UNITED STATES PATENT AND TRADEMARK OFFICE

10/828,843

Office Action Summary

DETAILED ACTION

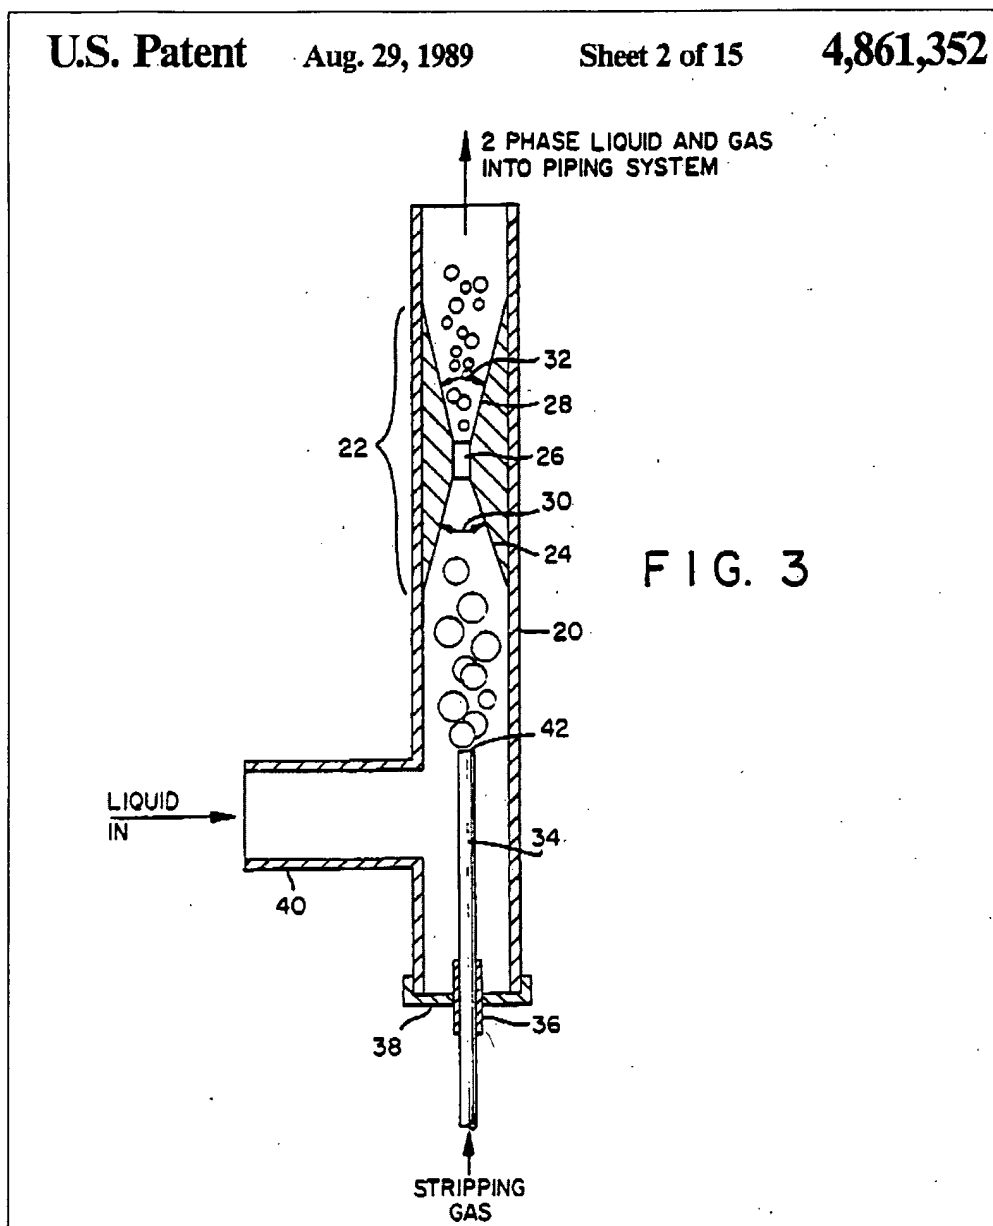
As shown in Fig. 1, Rentschler discloses a water remediation system.

From column 11 of Rentschler, beginning at line 5:

The stripper of Rentschler is in the process flowline, and hence, "*inline.*"
